Gold Line

BUS RAPID TRANSIT PROJECT • ENVIRONMENTAL ASSESSMENT (EA)
FINDING OF NO SIGNIFICANT IMPACT (FONSI)

ENVIRONMENTAL RE-EVALUATION

August 2020

FIGURE 2-20: 15% DESIGN CENTURY AVENUE

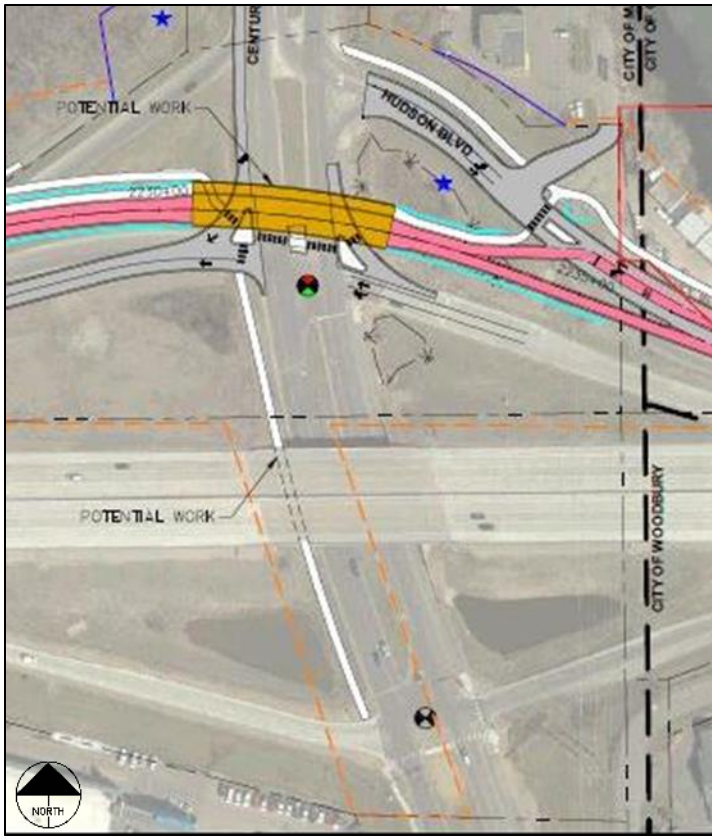
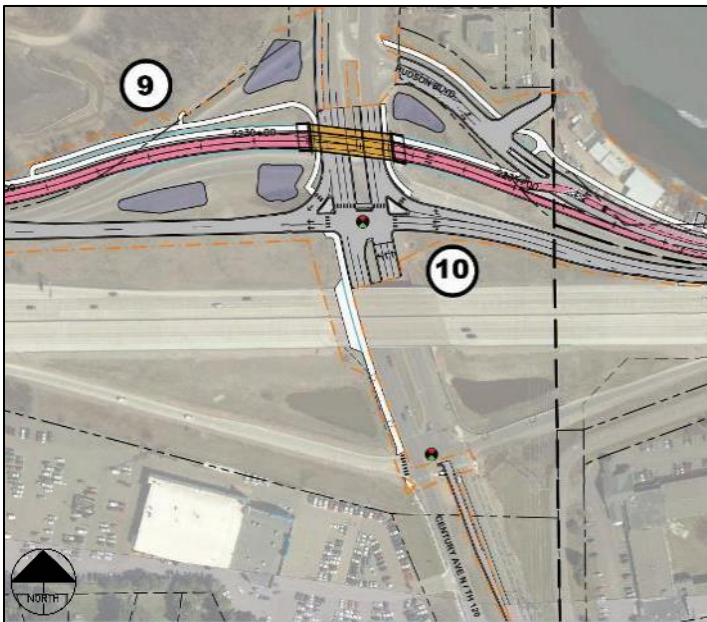
Table 2-11 summarizes impacts to resources potentially affected by the 30 percent design change for Century Avenue. Figure 2-20 and Figure 2-21 show 15 percent design and 30 percent design, respectively.

The proposed intersection reconstruction improvements reported in the EA/FONSI maintain an acceptable LOS D. Northbound left-turn queuing movement extends past I-94 eastbound ramps under both 2040 No-Build and Build conditions. The 30 percent design moves the westbound I-94 ramp intersection with Century Avenue further south, reducing storage for northbound to westbound left-turn movements. The 30 percent design extends left-turn storage south of the eastbound I-94 ramp intersection with Century Avenue by 150 feet to maintain traffic queuing. The added left-turn storage is accommodated within an existing median south of the intersection. Coordination with FHWA occurred related to the potential need of an Interchange Access Report (IAR). FHWA concurred that an IAR would not be needed. That documentation can be found in Appendix A.

FIGURE 2-22: 15% DESIGN APOSTOLIC BIBLE INSTITUTE

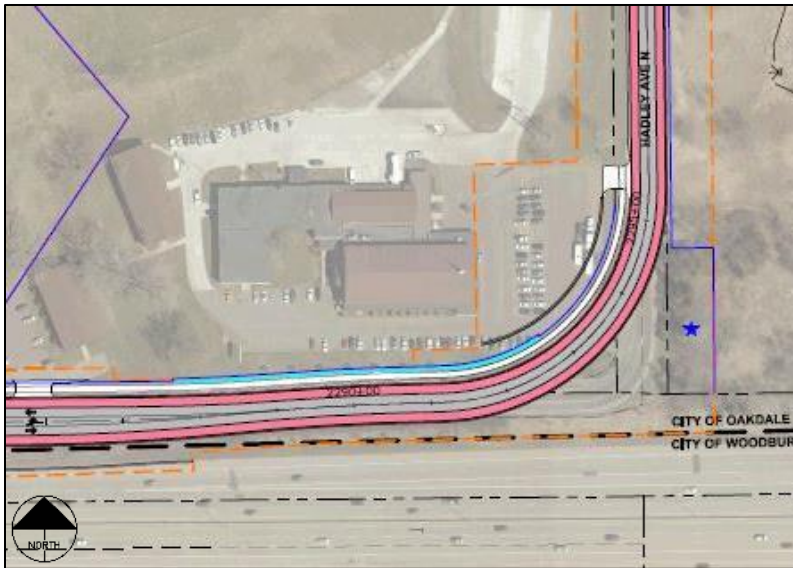
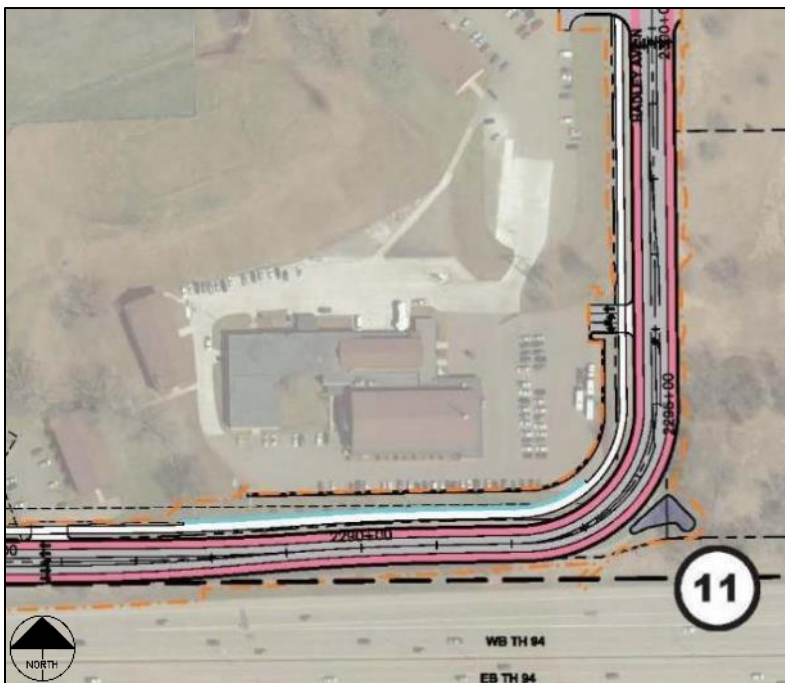
Table 2-12 summarizes impacts to resources potentially affected by the 30 percent design change at the Apostolic Bible Institute. Figure 2-22 and Figure 2-23 show 15 percent design and 30 percent design, respectively.

The guideway design presented in the EA/FONSI required approximately 3.38 acres from the ABI property. With the reduced guideway impacts noted previously, the estimated acquisition is reduced to approximately 0.59 acres with the 30 percent design modifications.

The EA/FONSI identified the eight removed parking spaces and shifted driveway access as an impact to ABI as a community facility. The impact to this community facility is reduced as noted in Section 4.11.1 and Section 4.11.2. No other changes to community character and cohesion are expected with the 30 percent design modifications.

FIGURE 2-24: 15% DESIGN HELMO PARK-AND-RIDE

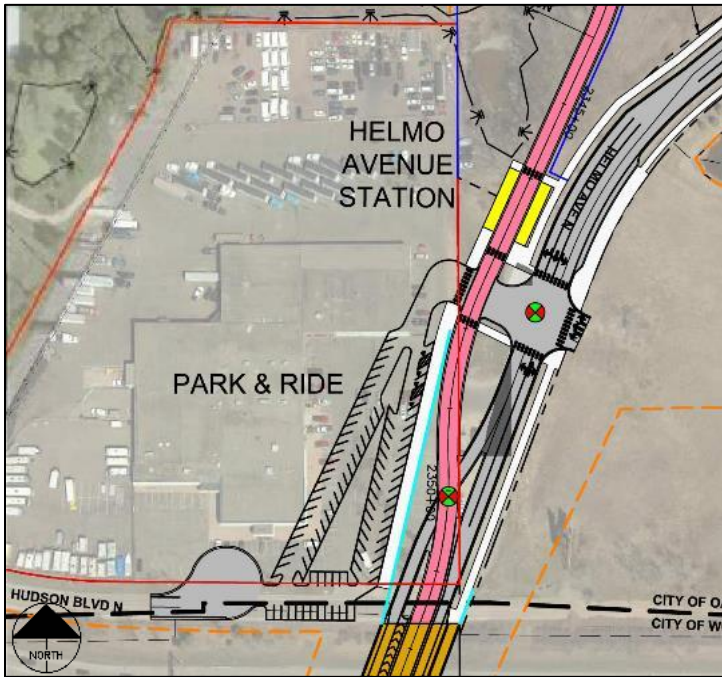
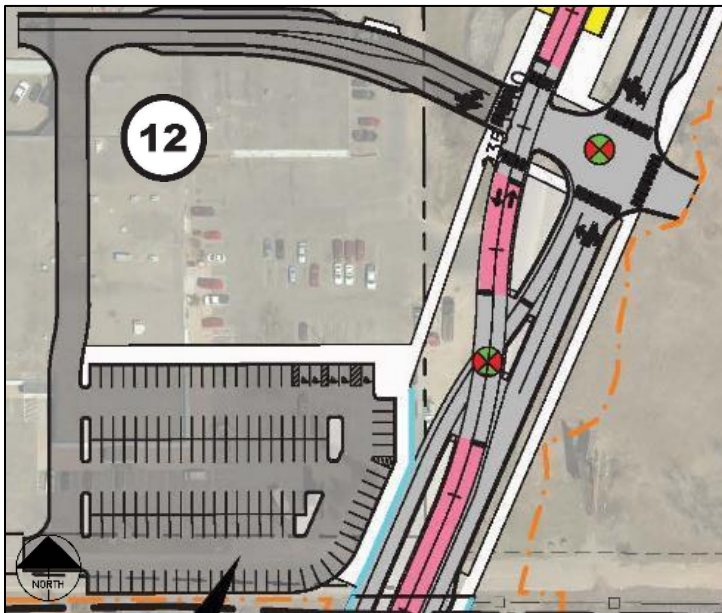
Table 2-13 summarizes impacts to resources potentially affected by the 30 percent design change for the Helmo Park-and-Ride. Figure 2-24 and Figure 2-25 show 15 percent design and 30 percent design, respectively.

The EA/FONSI reports that in response to plans for the Project, the portion of Helmo Avenue south of 4th Street and extending to Hudson Boulevard, is planned for mixed-use TOD and park-and-ride. The 30 percent design for the Helmo Park-and-Ride and access routes remain consistent with the City of Oakdale's land use plans.

The EA/FONSI noted the Project would fully acquire one parcel from Crossroads Properties Inc. to construct the Helmo Avenue Station Park-and-Ride, which would eliminate 156 parking spaces but add 100 parking spaces. The impact was not identified as significant as the site is proposed for future TOD use. The 30 percent design adds another 38 parking spaces for a total of 138 parking spaces to further support TOD plans and increase the project rating.

FIGURE 2-26: 15% DESIGN NORTH OF I-94 AT 4TH STREET AND HELMO AVENUE (MN PIPELINE)

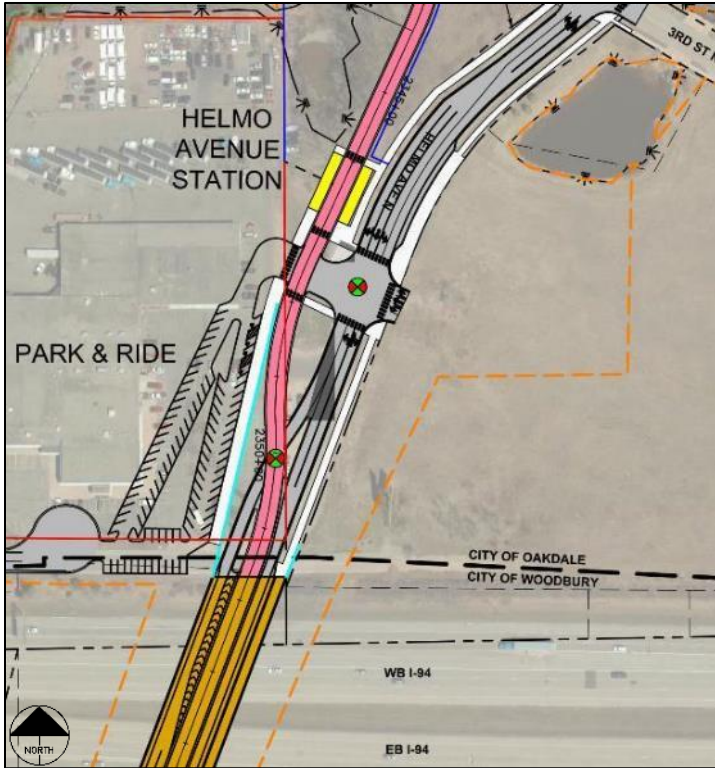
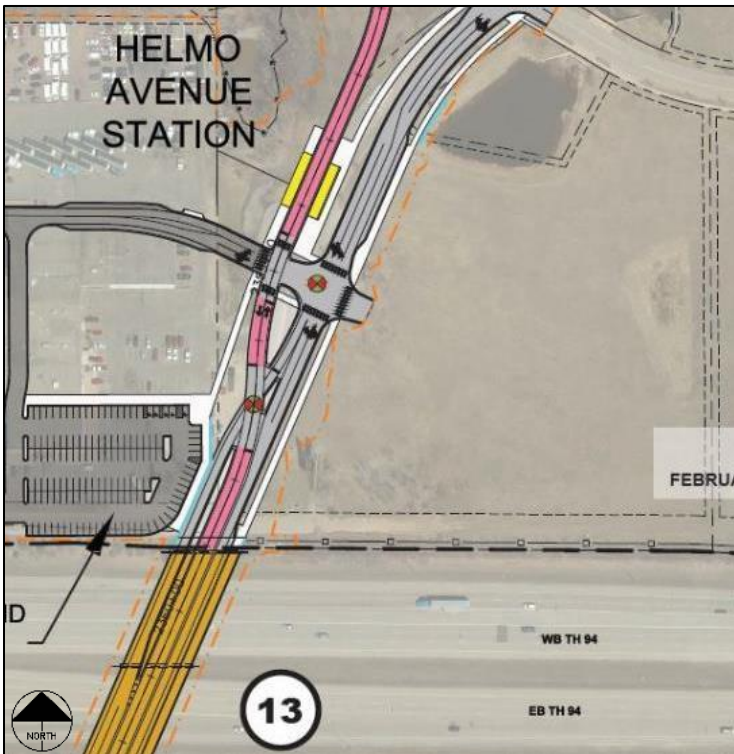
Table 2-14 summarizes impacts to resources potentially affected by the 30 percent design change north of I-94 at 4th Street and Helmo Avenue (MN Pipeline). Figure 2-26 and Figure 2-27 show 15 percent design and 30 percent design, respectively.

The EA/FONSI estimated the BRT guideway impacted 3,820 cubic yards of floodplains at waterbody BC-53. The 30 percent design as noted in Section 4.13.3 reduces impacts to 2,388 cubic yards. The Joint WCA/404 permit recently received for the Project accounts for this revised impact.

The EA/FONSI estimated the BRT guideway impacted 0.43 acre at Wetland 48-1. The 30 percent design, as noted in Section 4.13.3, reduces impacts to 0.27 acre. The Joint WCA/404 permit recently received for the Project accounts for this revised, smaller impact.

The EA/FONSI identified that the LOD for the guideway alignment travels through 11.7 acres of the High Potential Zone (HPZ) for the Rusty Patched Bumble Bee (RPBB). The modified LOD for 30 percent design reduces impacts in the HPZ to 7.1 acres. The U.S. Fish and Wildlife Service (USFWS) concurred the Project may affect, but is not likely to adversely affect, the RPBB based on 30 percent design. The Council further committed to continued coordination with the USFWS to avoid and minimize construction impacts during the RPBB active season and avoid impacting suitable overwintering habitat during the inactive season. Disturbed areas will be reseeded with a native floral seed mix. The Council also committed to conducting field surveys with USFWS during the Spring/Summer 2021 to determine presence of the RPBB in the HPZ within the Project's 30 percent LOD. The USFWS Section 7 concurrence remains valid with these changes.

FIGURE 2-28: 15% DESIGN SOUTH OF I-94 AT 500 BIELENBERG DRIVE STORMWATER BMP

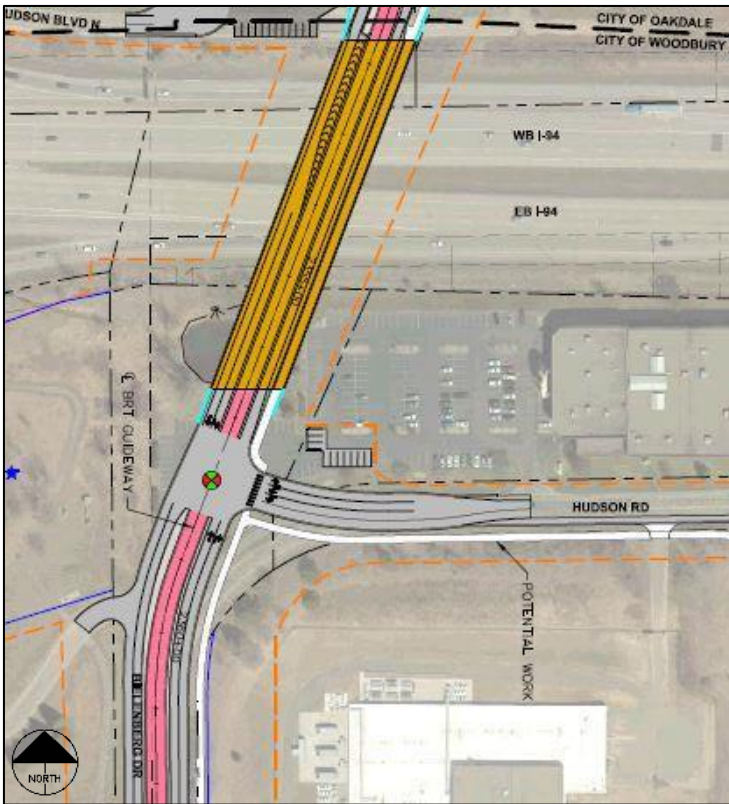
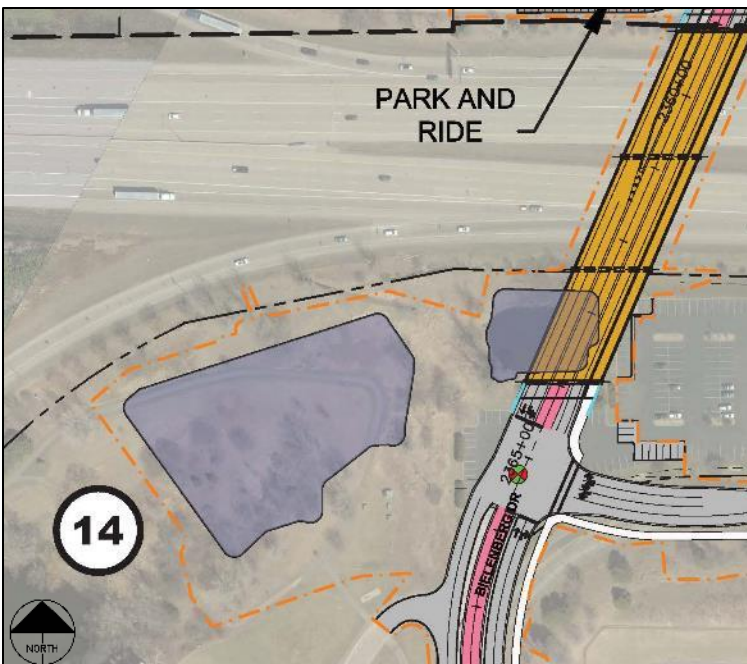
Table 2-15 summarizes impacts to resources potentially affected by the 30 percent design change south of I-94 at 500 Bielenberg Drive. Figure 2-28 and Figure 2-29 show 15 percent design and 30 percent design, respectively.

The EA/FONSI reports that alignment D3 would add or reconstruct 29 acres of impervious surface, which would require volume and rate control to use existing storm sewer systems. An approximately 0.7-acre stormwater BMP was proposed west of the Bielenberg Drive/Hudson Road intersection.

The EA/FONSI identified that the LOD for the guideway alignment travels through 4.6 acres of RPBB HPZ. The modified LOD for 30 percent design reduces impacts in the HPZ to 4.1 acres. The expanded BMPs will occur in an area of unmanicured upland grasslands with sparse tree/shrub cover. It is unlikely that the RPBB would be nesting in the area due to the proximity of existing roadways, soil compaction and the low quality of available floral resources.

FIGURE 2-30: 15% DESIGN BILENBERG DRIVE AND TAMARACK ROAD

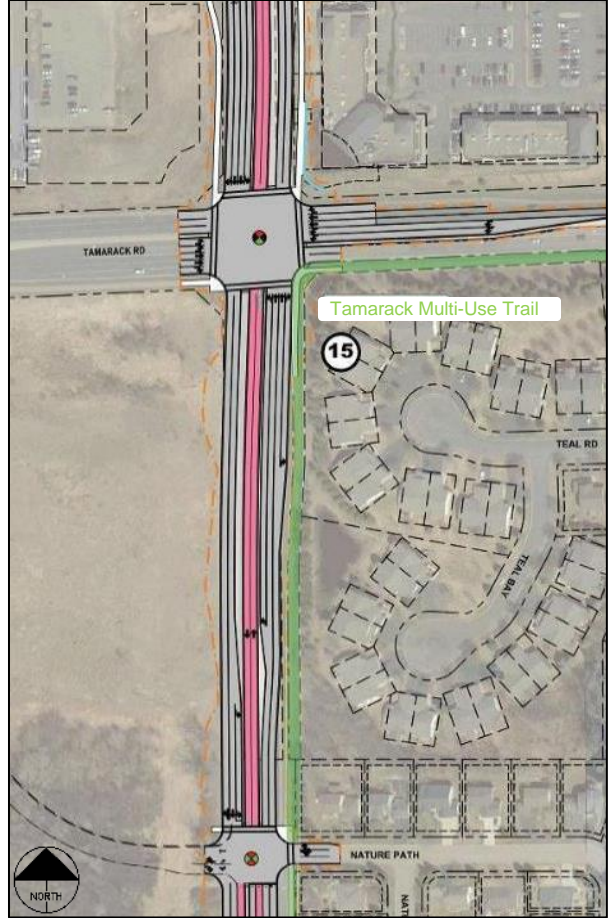
Table 2-16 summarizes impacts to resources potentially affected by the 30 percent design change at Bielenberg Drive and Tamarack Road. Figure 2-30 and Figure 2-31 show 15 percent design and 30 percent design, respectively.

The EA/FONSI found the proposed shared through/right-turn lane for the northbound to eastbound traffic movement would not result in further decline in level of service. Based on input from the City of Woodbury, the 30 percent design includes a 300-foot northbound right-turn lane which could improve traffic operations by reducing queueing.

The proposed roadway reconstruction in the EA/FONSI required shifting the multiuse trail 4.5 feet east of its existing alignment within the transportation ROW. This shift remains unchanged with the 30 percent design.

FIGURE 2-32: 15% DESIGN GUIDER DRIVE

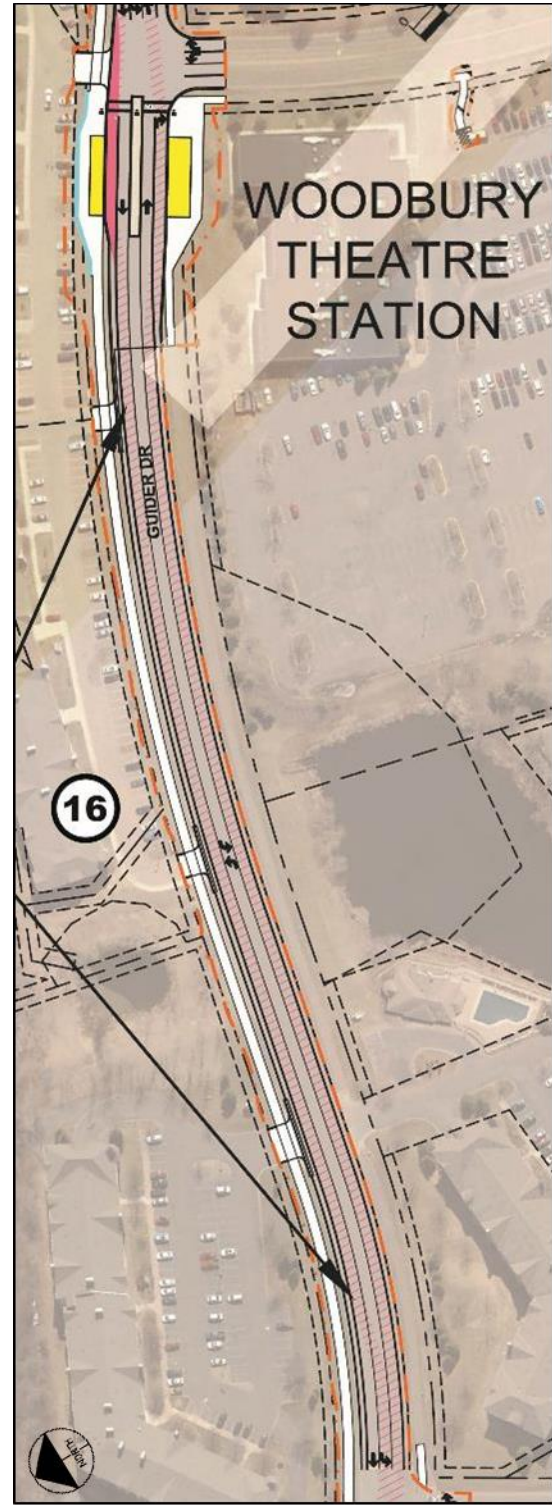
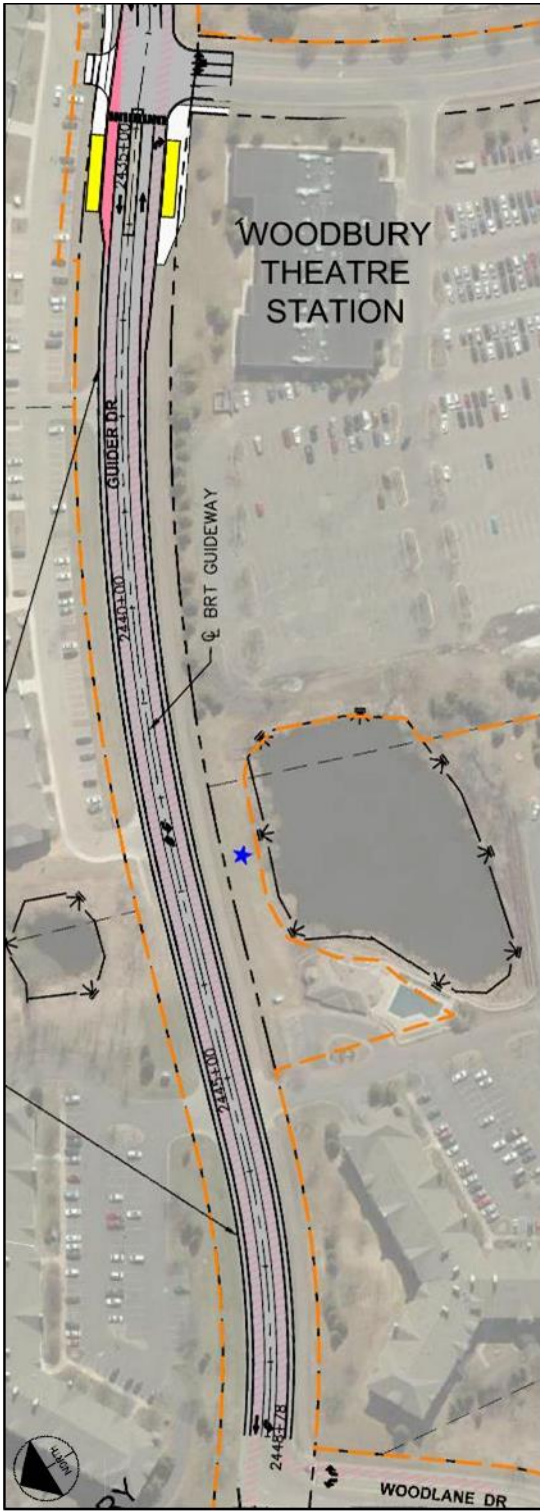
Table 2-17 summarizes impacts to resources potentially affected by the 30 percent design change at Guider Drive. Figure 2-32 and Figure 2-33 show 15 percent design and 30 percent design, respectively.

The EA/FONSI did not identify permanent acquisition at the Woodbury Theatre Station to accommodate a trail connection to Bielenberg Drive. The trail extension behind the station platform requires approximately 0.4 acre of permanent acquisition from an open space area at a multi-residential complex located between the parking lot and street .

The EA/FONSI presented a trail connection between Bielenberg Drive and the Woodbury Theatre Station. The 30 percent design that extends the trail connection from the Woodbury Theatre Station to the Woodbury I-494 Park-and-Ride will improve pedestrian and bicycle access.
